# Barco service bulletin

**Serial Number:** 975  
**Date:** 05/05/2011  
**Product:** DP90, DP100 and DP-3000  
**Priority code\*:** C

## 1. HALF SPLIT SCREEN PROBLEMS ON DP90, DP100 AND DP-3000 DIGITAL CINEMA PROJECTORS

Image 1-1

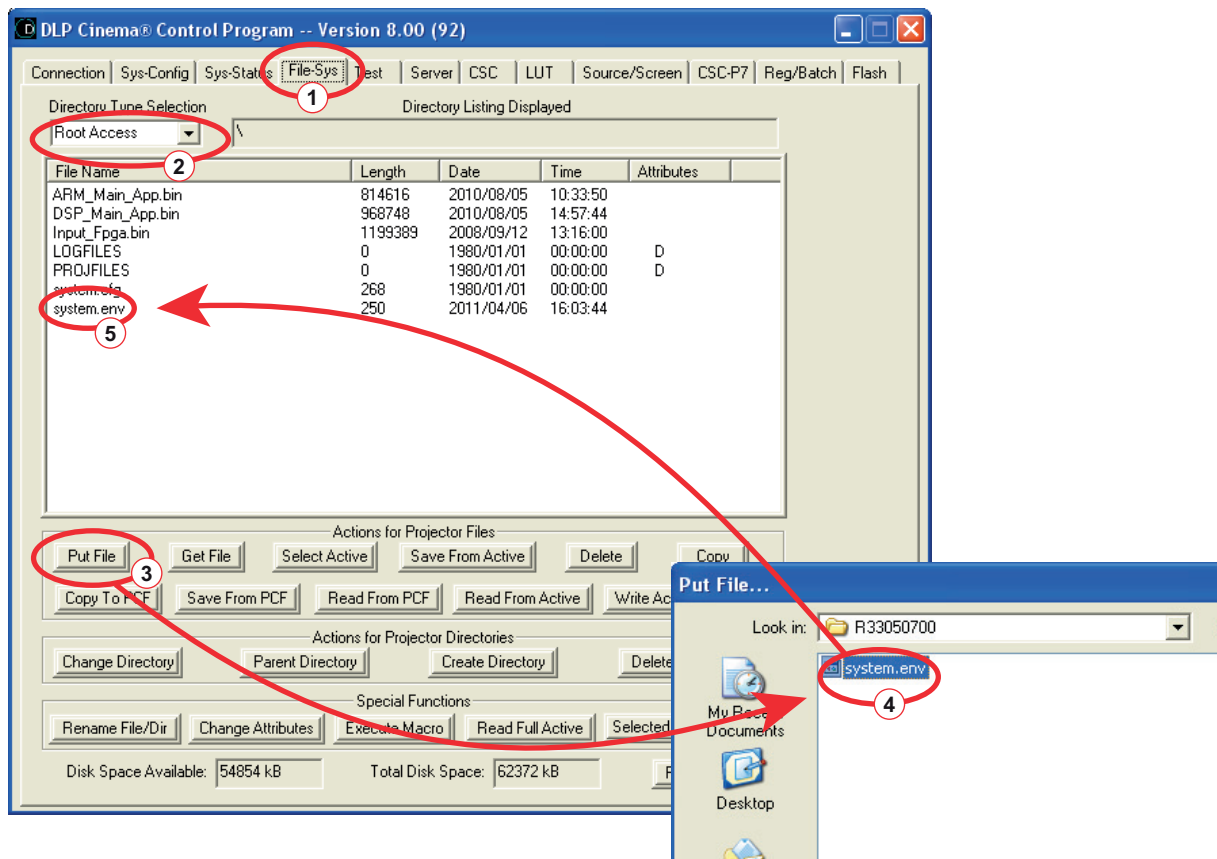
1. Ensure that the TI software package V15.1 is installed. If not, install as per normal installation instructions using the TI control application.
2. Install the **system.env** file, which is include in the **Half Image Patch for the TI software package v15.1.52** (R33050700), in the "File-Sys" > "Root Access" using the DLP Control Program > "Put file". If a previous system.env file is already in the root directory simply delete it.

Image 1-2

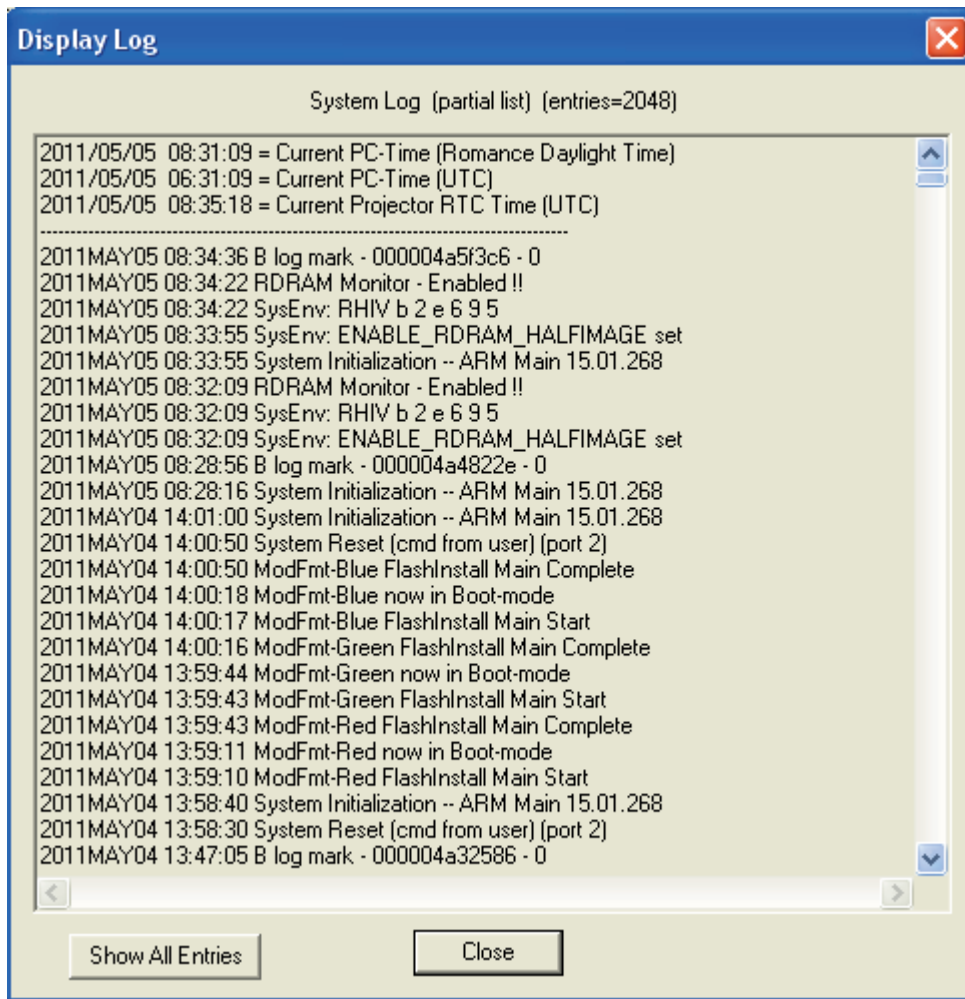
3. Power Cycle the projector.
4. Login to the TI electronics using the control application again.
5. View the TI System Logs. You should now see entries similar to below.
